## Process Sheet

<b>Customer</b>	: CU-DAR001 Dart Helicopters Services	<b>Drawing Name</b>	: PLUG
<b>Job Number</b>	: 40728		
<b>Estimate Number</b>	: 12337		
<b>P.O. Number</b>	:	<b>Part Number</b>	: D3492043
<b>This Issue</b>	: 23/07/2008	<b>S.O. No.</b>	:
<b>Prsht Rev.</b>	: NC	<b>Drawing Number</b>	: D3492 REV C
<b>First Issue</b>	: / /	<b>Project Number</b>	: N/A
<b>Previous Run</b>	: 39677	<b>Drawing Revision</b>	: C
	<b>Type</b> : MACHINED PARTS	<b>Material</b>	:
<b>Written By</b>	:	<b>Due Date</b>	: 01/08/2008
<b>Checked &amp; Approved By</b>	: <u>JUD 08.7.23</u>	<b>Qty:</b>	50 <b>Um:</b> Each
<b>Comment</b>	: Est Rev: A 06.03.21 New Issue JLM : Est Rev: B 06-08-28 As per Rev B JLM : Est Rev: C 07-12-06 Rev C dwg DD verified by: EC : Est Rev: D 08-05-07 add note to count qty DD verified by: JLM

C	ADD -049/-051/-053, CHANGE DRAWING FORMAT	PH	07.10.05
B	ADD -047; UPDATE DIM A FOR -045	PH	06.05.11
A	NEW ISSUE	PH	06.01.04
REV.	DESCRIPTION	BY	DATE
DESIGN		<b>DART AEROSPACE LTD</b> HAWKESBURY, ONTARIO, CANADA	
DRAWN			
CHECKED		DRAWING NO.	REV. C
MFG. APPR.		D3492	SHEET 1 OF 2
APPROVED		TITLE	SCALE
DE APPR.		PLUG	2:1
DATE	07.10.05	COPYRIGHT © 2007 BY DART AEROSPACE LTD THIS DOC

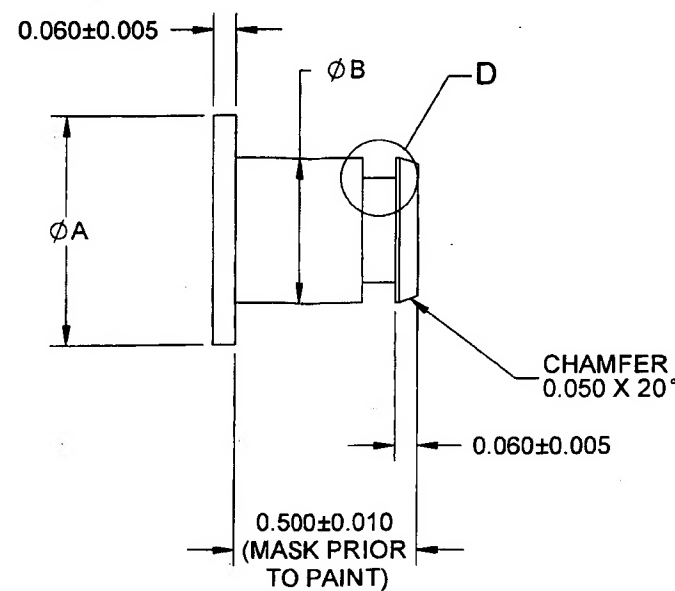
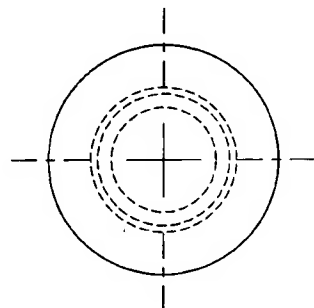
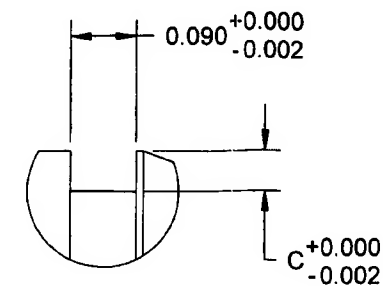
PL 06.07.23  
**UNDER REVIEW**  
07/07/21  
DIM ØB ON D3492-13  
REST OK (MAKE SMALLER)
